CITY OF PORTLAND BUILDING PERMIT

Job ID: 2011-11-2633-ALTCOMM - CHG OF USE

Proposed Project Description: Renovations 38 Unit Apartment Underground Parking		Pedestrian Activities District (P.A.D.) 1/27/12

ELM TERRACE
 68 HIGH STREET
 PORTLAND, MAINE

Wright Ryan – Site & Building Shoring Extents Plan

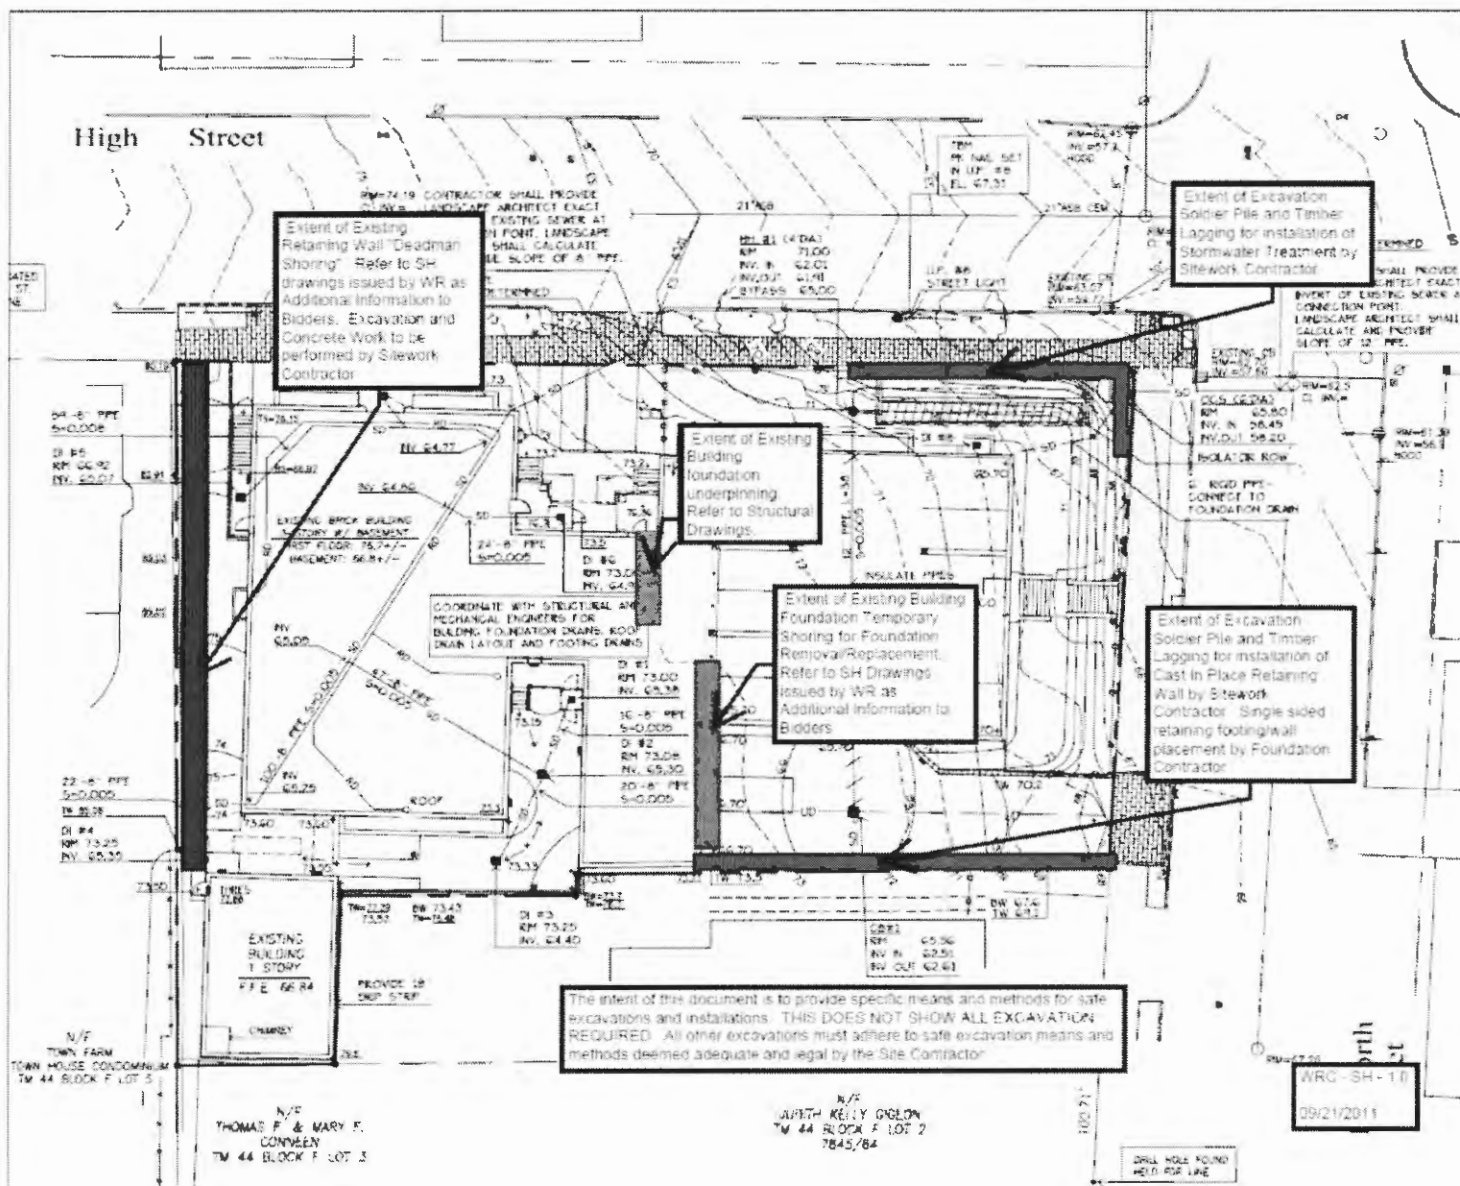
This document serves as additional instructions to potential subcontractors as it pertains to Site and Building Shoring.

- Shoring of existing building
 - Work is to be priced in accordance with documents included in Addendum 1 as additional information available to bidders
 - Substitute approaches will be entertained post bid
- Shoring of existing retaining wall
 - Work is to be priced in accordance with documents included in Addendum 1 as additional information available to bidders
 - Substitute approaches will be entertained post bid
- Excavation Shoring
 - Work is to be priced in accordance with documents included in Addendum 1 as additional information available to bidders
 - The design intent assumes the use of Soldier Pile with Timber Lagging
 - Vibratory Sheet Pile is not permissible.
 - Substitute approaches will be entertained post bid
- All other excavation support measures not indicated on the documents shall be the responsibility of the sitework contractor.

SKS-1-1

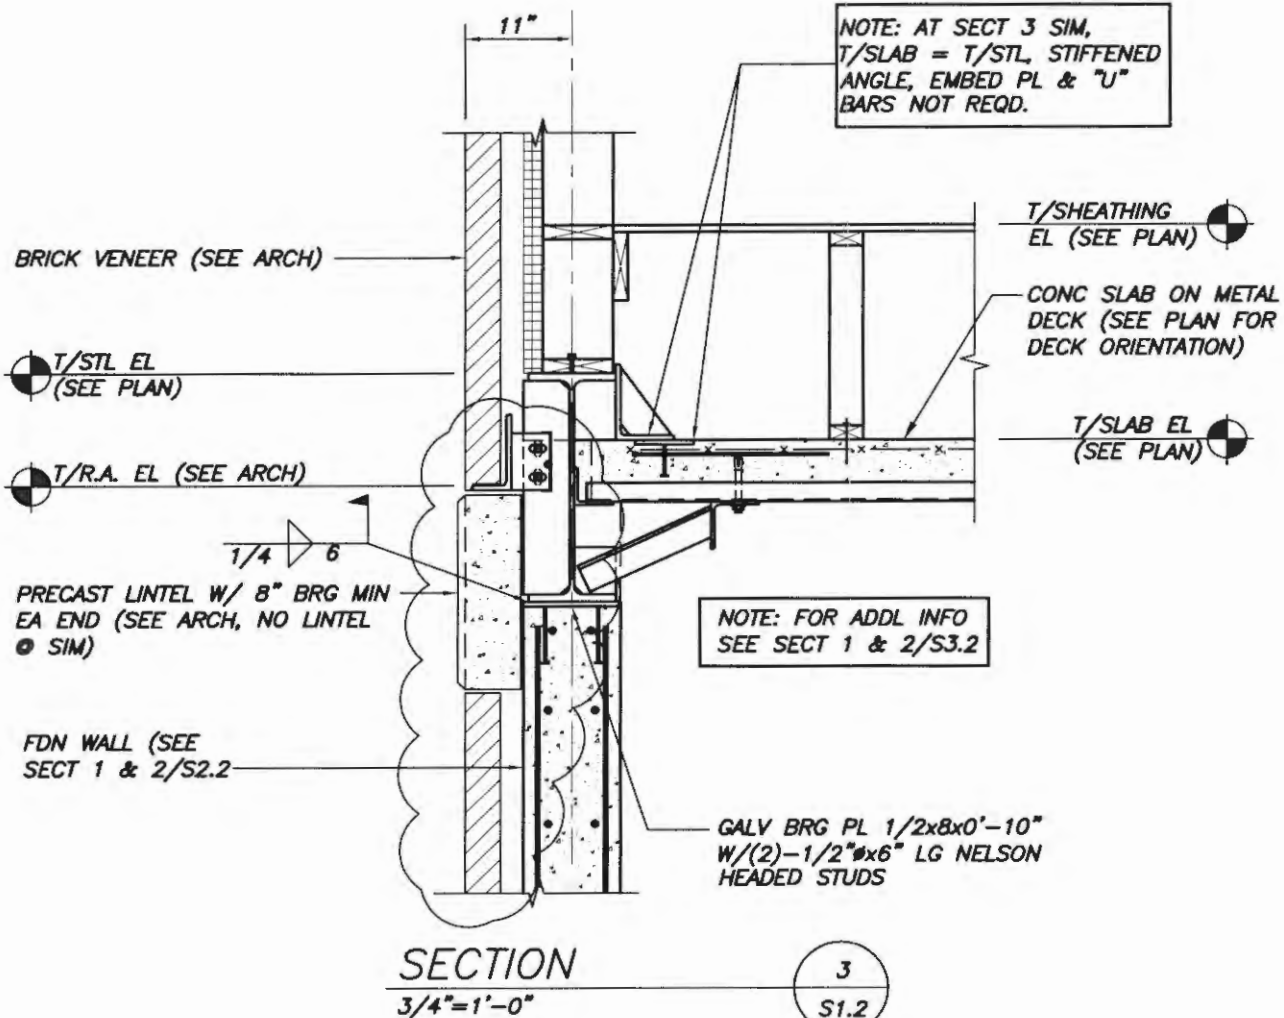
7. Replace detail 2 on Drawing S3.2 with the attached SKS-1-1.
8. Replace detail 3 on Drawing S3.2 with the attached SKS-1-2.
9. Provide square concrete column wraps (not round as indicated on Drawing S1.1) at all six (6) steel columns in the enclosed parking garage area [PARKING GARAGE - 001] per attached SKS-1-3.
10. At all continuous bearing floor trusses to be installed directly over the first floor concrete slab subfloor structure of the building addition wing, a) MSR lumber ratings are not required; and b) the bottom plate of the trusses shall be pressure treated.
